MEETING: **BUILDING CONSTRUCTION OVERSIGHT COMMITTEE**

DATE AND TIME: **THURSDAY, APRIL 30, 2020 7:00 p.m.**

Re: Firemen's Park Shelter – Review & Discussion – 30% Project Plans

ITEM TITLE: Dheinsville Pavilion-Color Selection

TOWER #3 - MEQUON ROAD

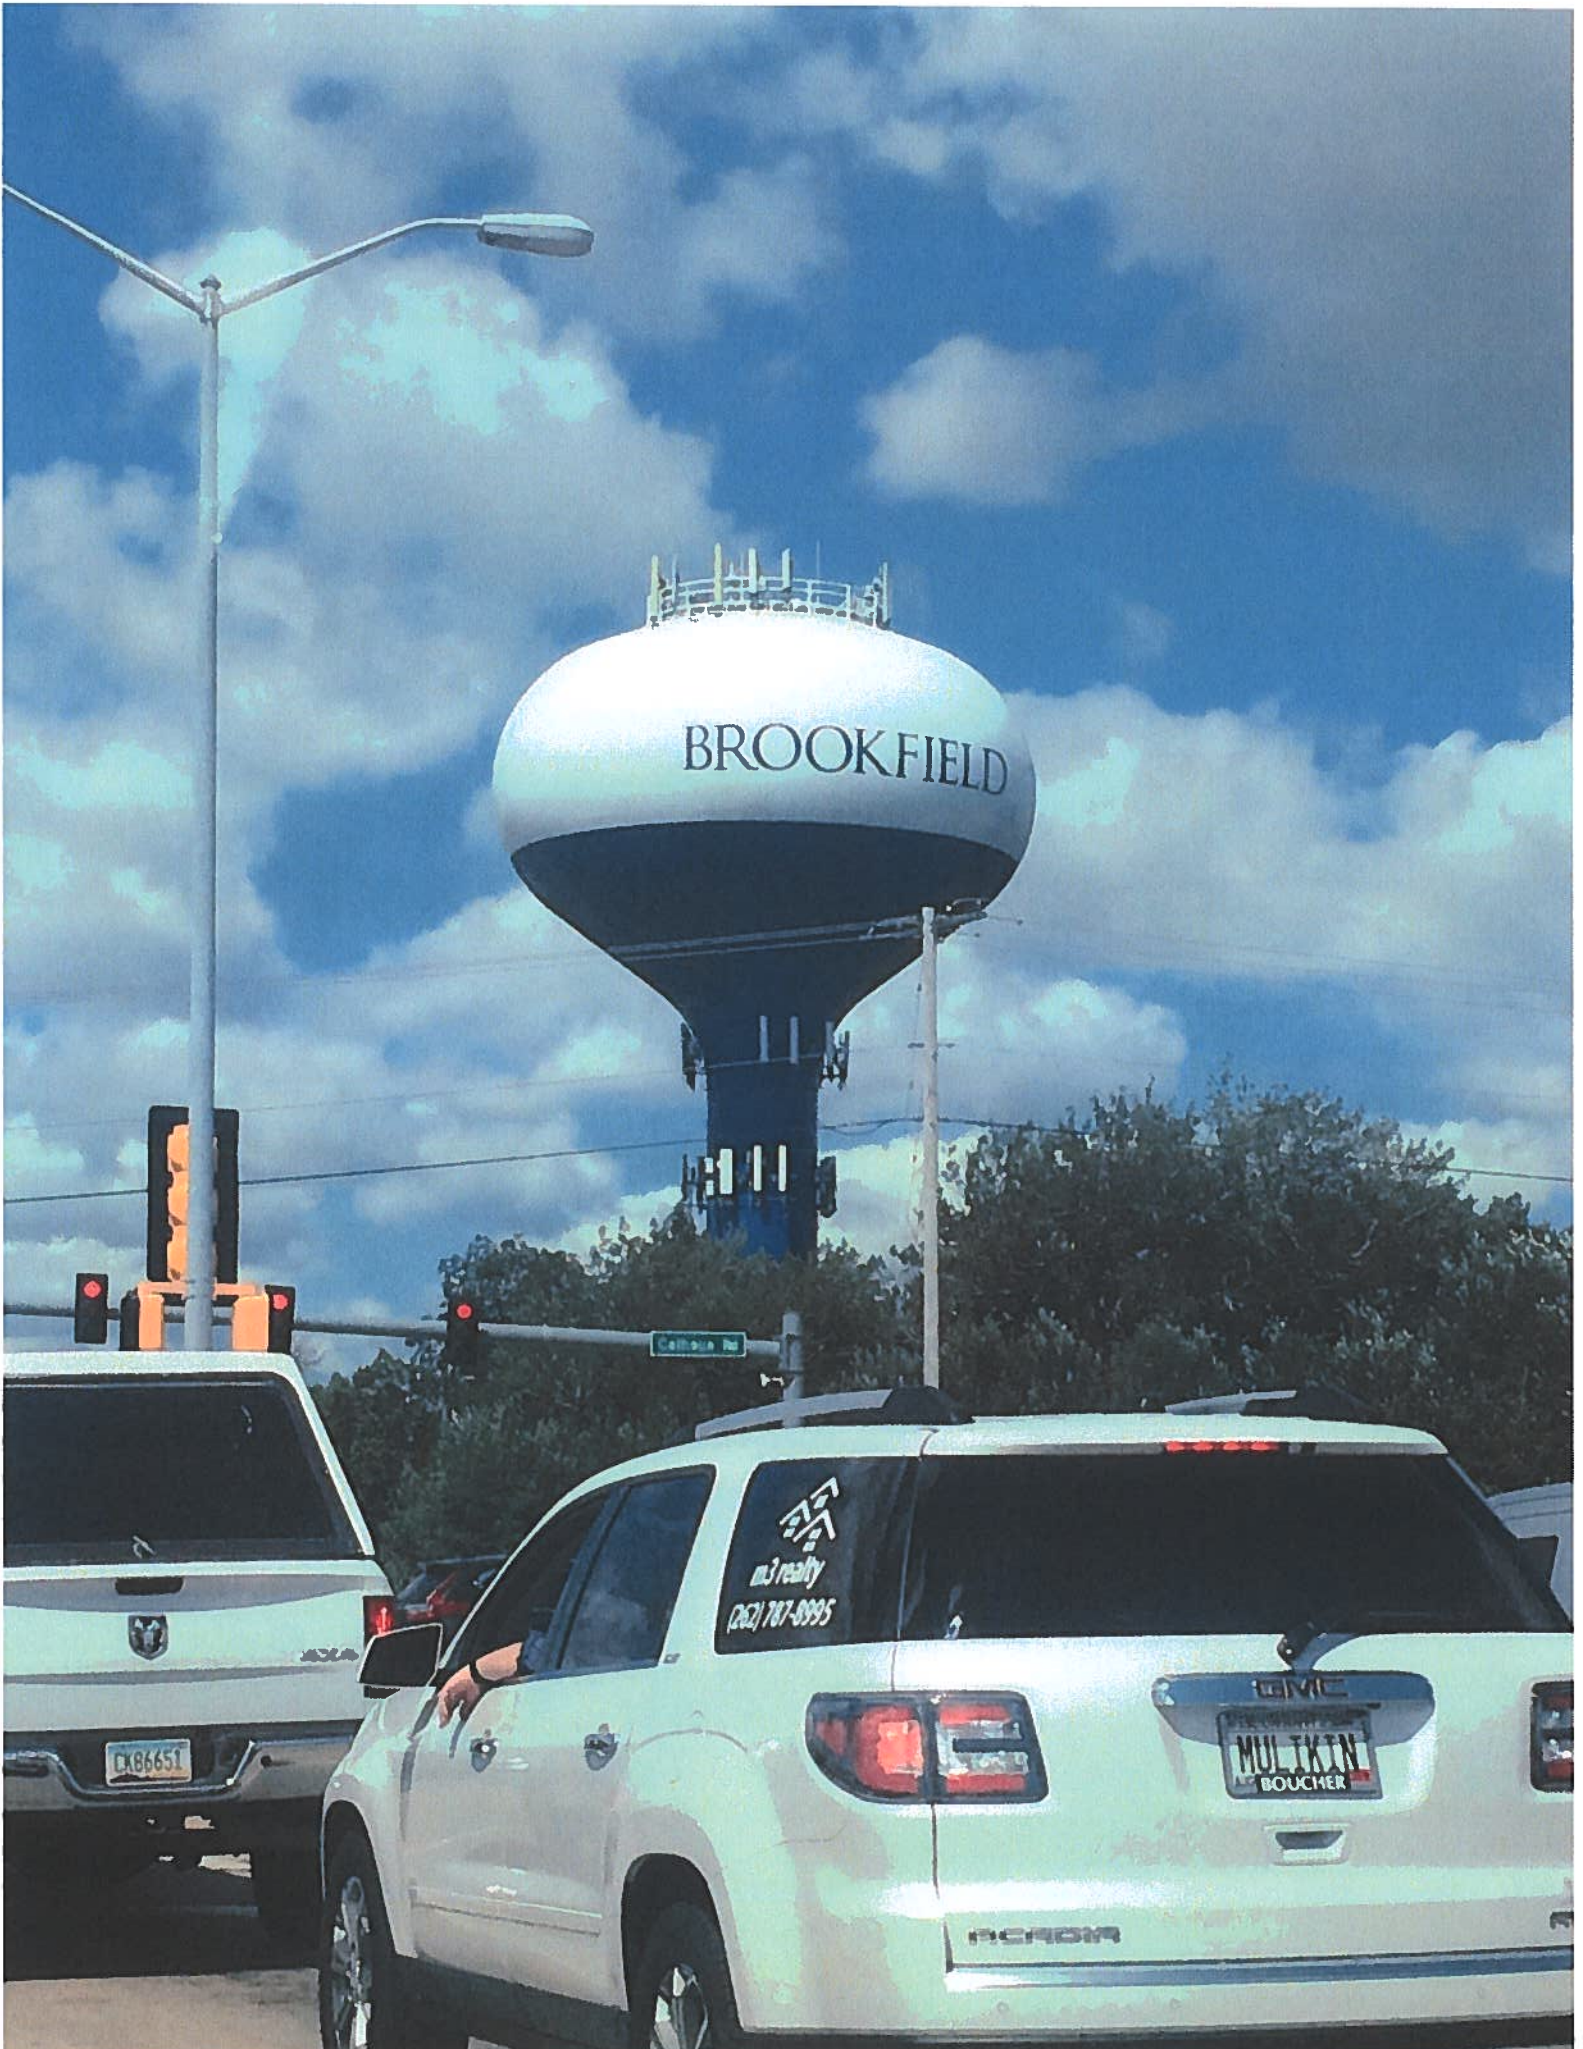
With the forthcoming construction of a new elevated water tank (water tower) at Gateway Crossing & Rockfield Rd., staff is interested in determining a color scheme for this very visible Water Tower. Staff is recommending a change to the color scheme and logo utilized in the past and discuss a refreshed appearance for the new and current Water Towers as they get repainted.

Evaluation of the ability of the Germantown flag logo to take the abuse of local weather conditions and ultraviolet rays is very poor. The colors fade becoming hard to recognize and are costly to place on a Water Tower. Staff is suggesting no flag logo and lettering that is easier to read from a distance and at highway speeds. This Water Tower, due to its location and elevation will be the most visible Water Tower in the area and staff feels that Germantown should take advantage of this fact.

Staff is requesting the BCOC give direction on paint scheme and writing on elevated water tank
